## ADDENDUM #9

**Western Slope Food Bank of the Rockies**  
698 Long Acre Drive

**Bid Package #4 – Above Ground**

Architect's Project No. 2108

**KITCHEN -PLUMBING ROUGH-IN PLAN**  
SCALE: 1/4" = 1'-0"

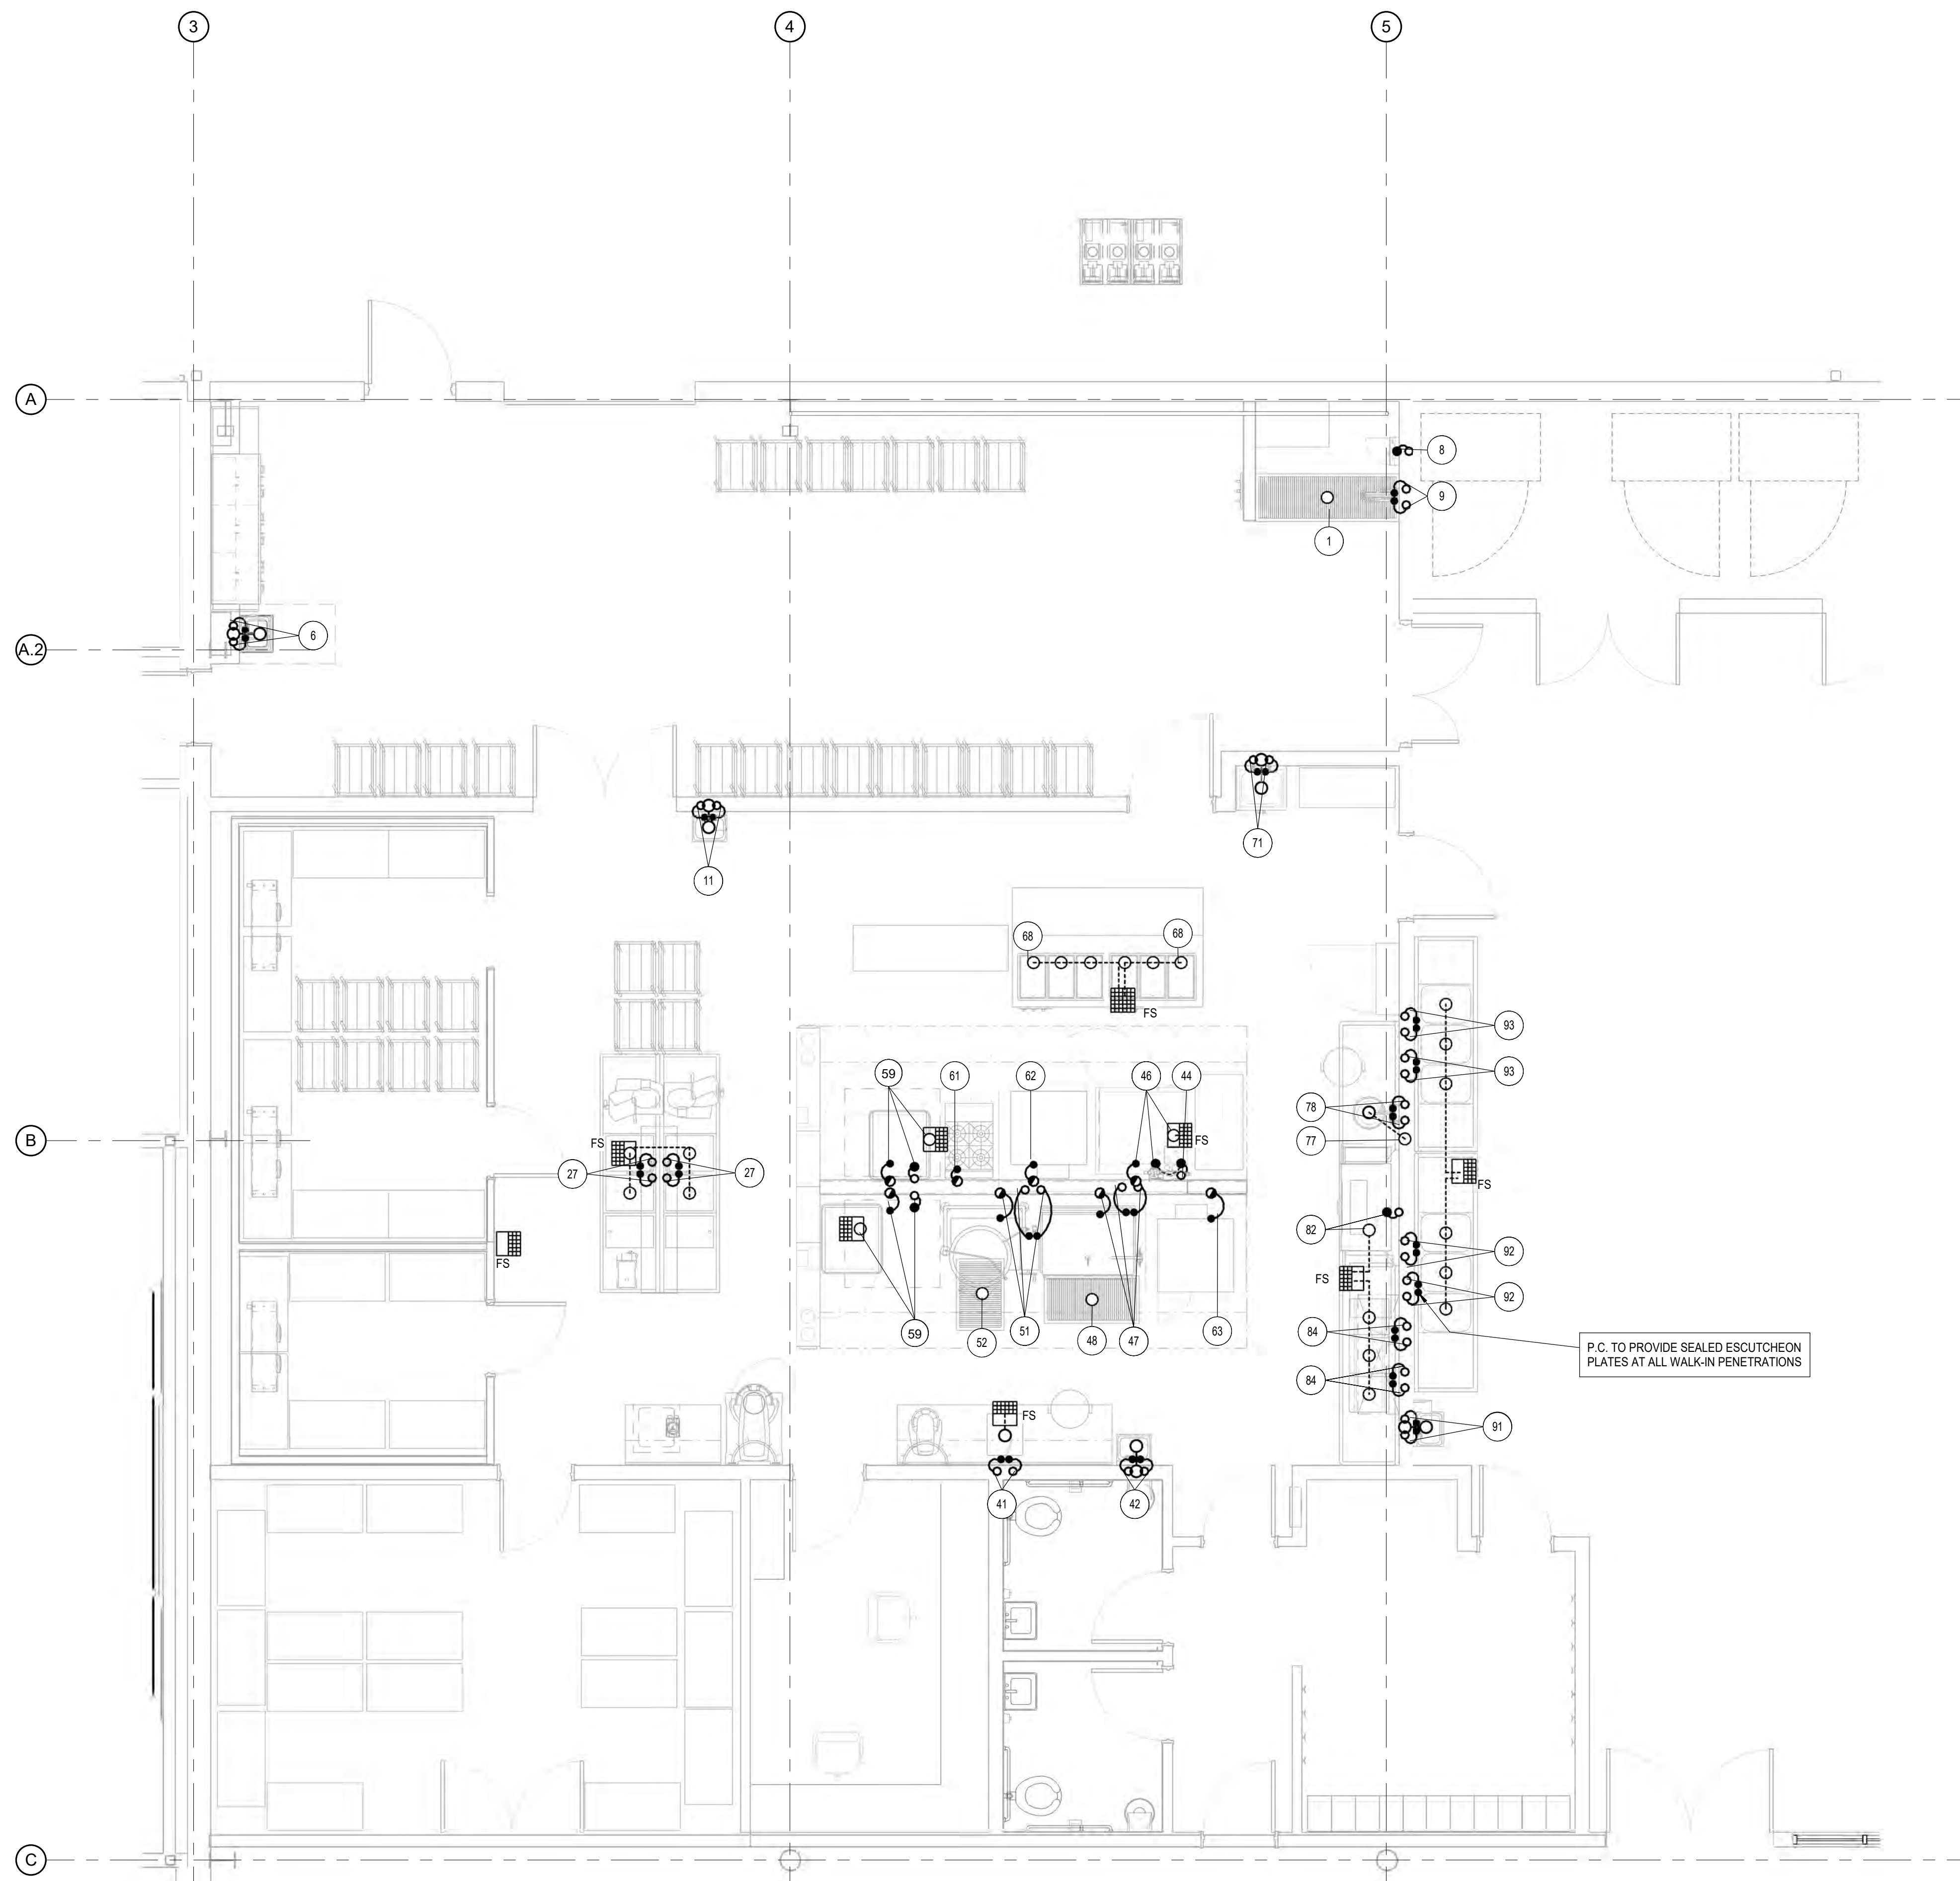
ALL WORK ON THIS SHEET SHALL BE PROVIDED (FURNISHED AND INSTALLED) IN THIS CONTRACT, INCLUDING MECHANICAL, PLUMBING, AND ELECTRICAL ROUGH-IN. ALL FLOOR DRAINS, FLOOR SINKS AND FLOOR TROUGHS SHALL BE PROVIDED UNDER THIS CONTRACT. ADD #9

**KITCHEN - ELECTRICAL ROUGH-IN PLAN**  
SCALE: 1/4" = 1'-0"

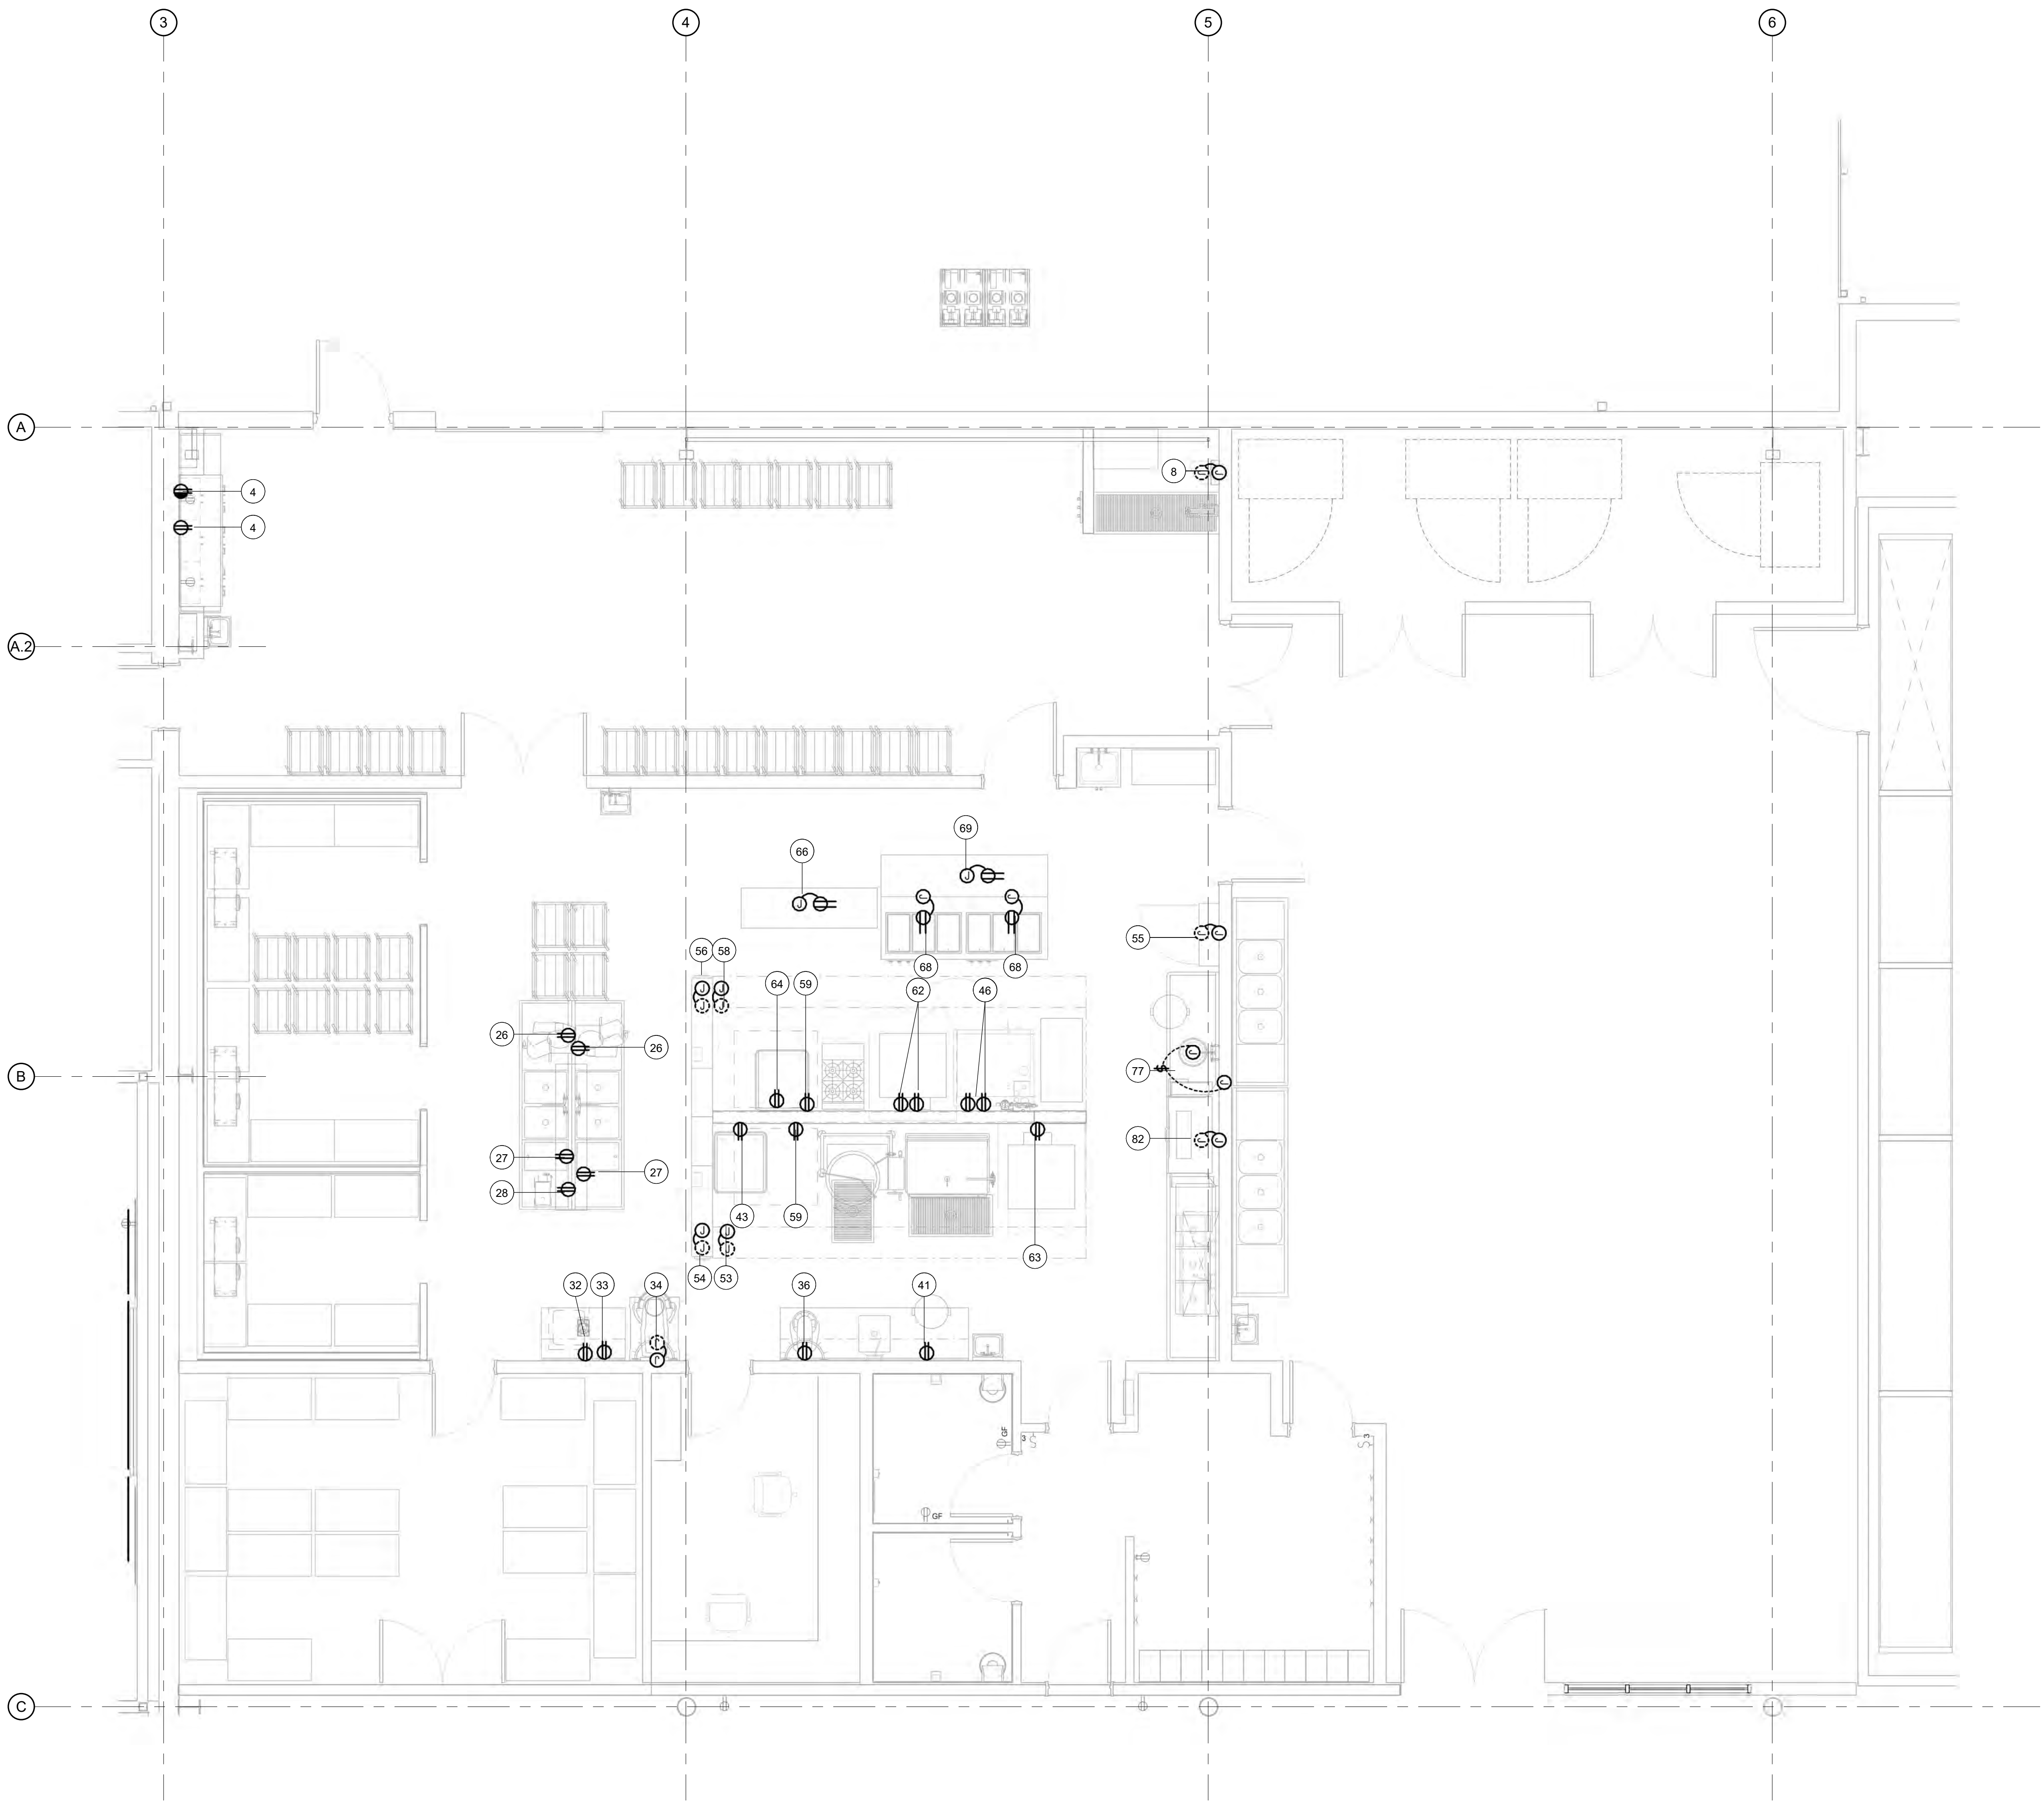
ALL ELECTRICAL ROUGH-IN AND ALL WORK ON THIS SHEET SHALL BE PROVIDED UNDER THIS CONTRACT. ADD #9
